RESPONSE TO REQUEST FOR ADDITIONAL INFORMATION

APR1400 Design Certification

Docket No. 52-046

RAI No.: 374-8481

1.9 Channel Identification

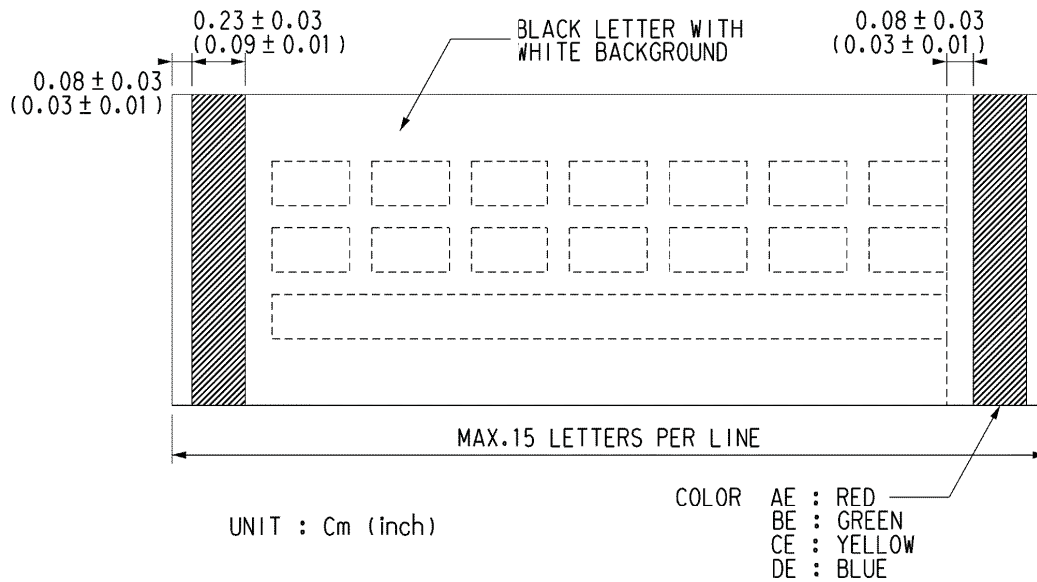
The last sentence in the Style Guide, Appendix D, Section 1.9, “Channel Identification,” appears to the staff to be missing because it indicates that some information is to be provided.

Please provide any missing information.

The color-coded nameplates for the safety console channels will be added to Section 1.9 of the Style Guide, as indicated in the attachment associated with this response.

Regarding identification of redundant Class 1E components, the following method of identifying separation group channelized controls and indicators on the safety console should be applied. This is in accordance with USNRC Reg. Guide 1.75 and in keeping with KEPCO's color-coding for related plant equipment. Each channel A, B, C, or D device on the safety console should be identified by the following color-coded nameplates.
